BOSTON EDISON COMPANY  
800 BOYLSTON STREET  
BOSTON, MASSACHUSETTS 02199

June 16, 1986  
BECO Ltr #86-079

Subject: Second Response to NRC Confirmatory Action  
Letter #86-10, Regarding the Events Which  
Occurred on April 4, 11-12, 1986 at Pilgrim  
Nuclear Power Station

MIV16-6 (Should Be)

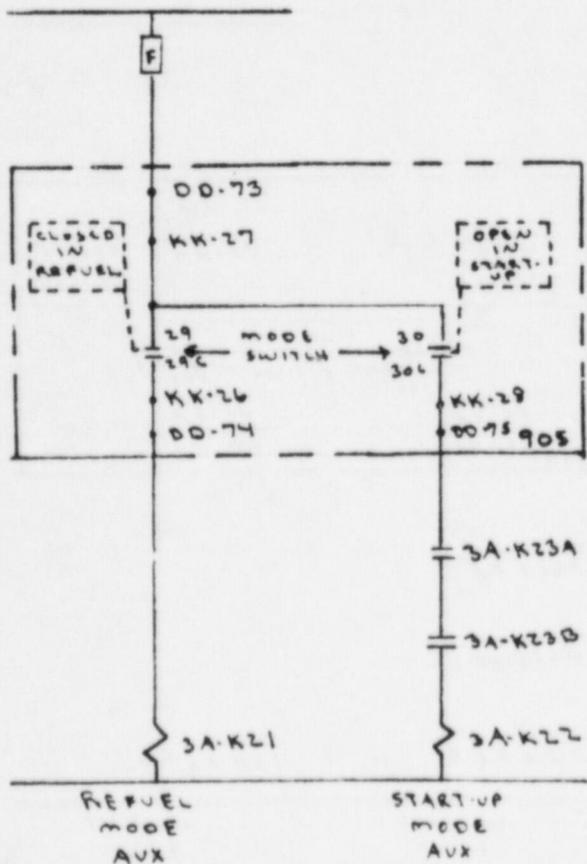
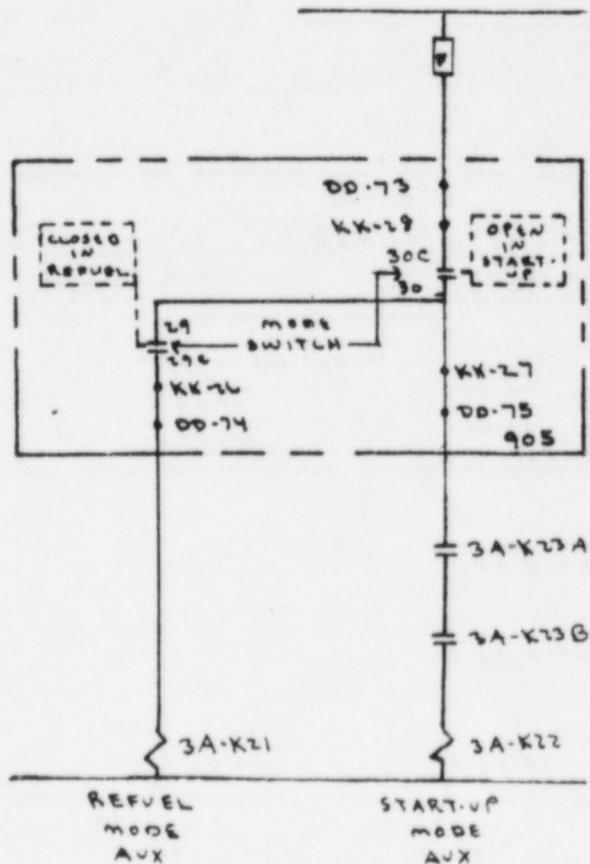
As a result of the performance of step 8 on page 11 of PNPS Procedure TP 86-64, Remove Existing SB-1 Type RMS, Replace with SB-9 Type RMS, a discrepancy was found between the Elementary Diagram MIV16-6 wiring and the "as found" wiring. The difference is shown below:

From these drawings it can be seen that in the "should be" MIV16-6 configuration, relay 3A-K21 can be energized independent of the position of RMS contact 30-30C and is solely dependent on the position of RMS contact 29-29C, i.e., the contacts are in parallel, while in the "as found" configuration, relay 3A-K21 is dependent on the position of both RMS contacts 29-29C and 30-30C, i.e., the contacts are in series. As a result, 3A-K21 could never be energized with contact 30-30C open, which is in conflict with the design diagram. This concept is outlined in the following table where blank=open, X=closed, 0=de-energized, 1=energized:

In response to Task 1, analysis of the Reactor Mode Switch circuitry and the Reactor Manual Control System Circuitry shows no potential effect on the MSIV closure. The RMS miswiring can in no way cause or prevent an MSIV closure.

In response to Task 2, since the miswiring could only result in the inability to withdraw a rod when desired, the resultant condition was more conservative than the design prints.

Data Sheet # 86-10-15  
Page 1 of 2

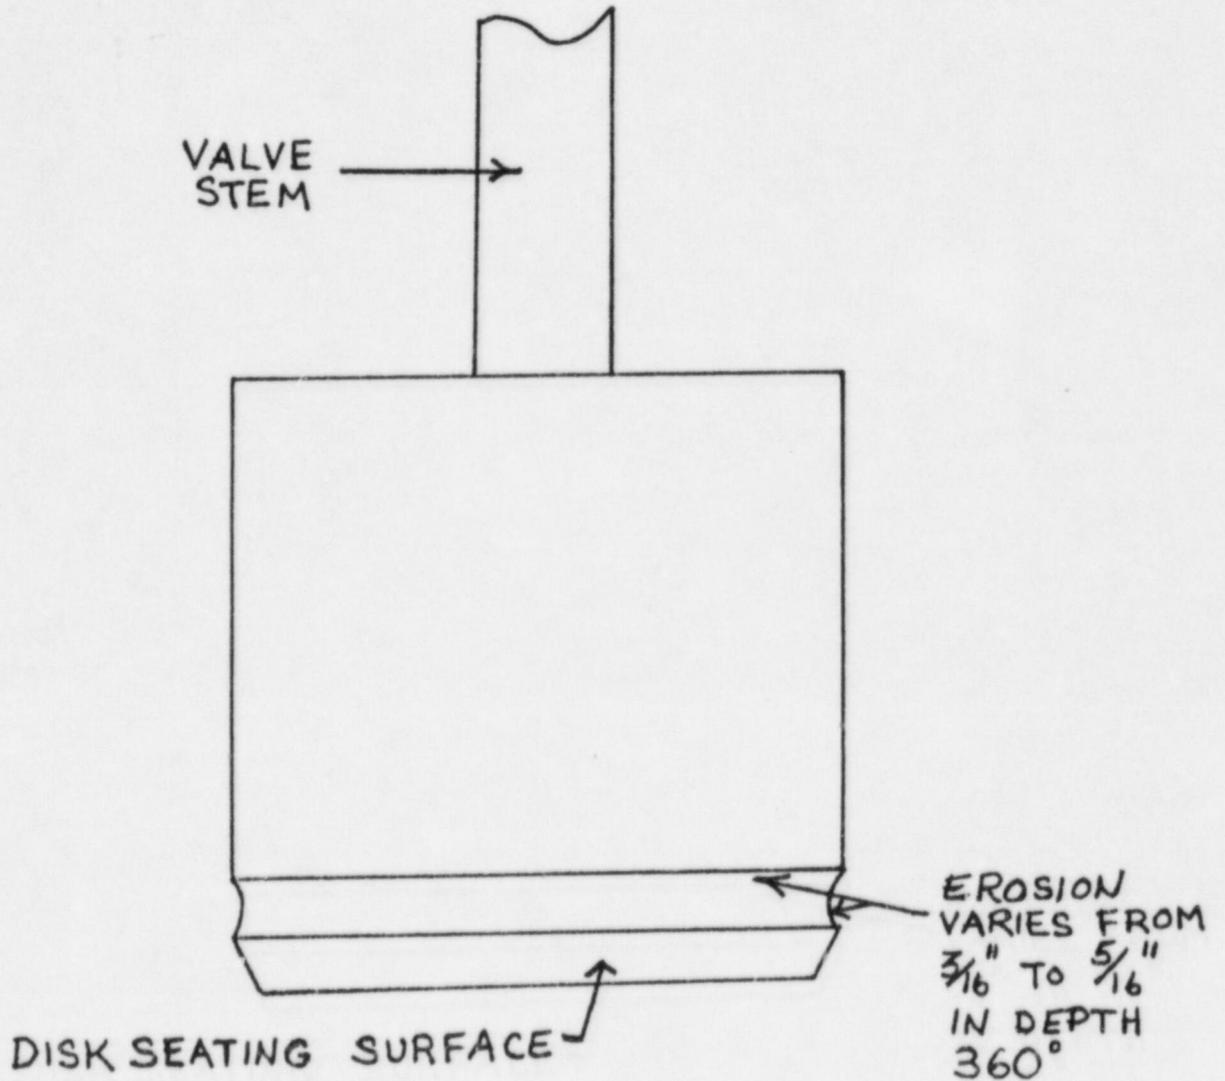
The valve was inspected by VT-3 examination methods Data sheet 86-10-15 documents the inspection and is included in this attachment. The inspection results record evidence of erosion above the valve seating surfaces on the body of the main disk. The erosion varied in depth from approximately 3/16" to 5/16" for the full circumference of the disk. The Nuclear Engineering Department (NED) was requested to review and respond to the acceptability of this finding.

Comments: SEVERE EROSION NOTED ON VALVE DISC - SEE ATTACHED SKETCH

Based on the postwork test results, the controlled leakoff method discussed in the answer to NRC question (e), was selected as our course of action.
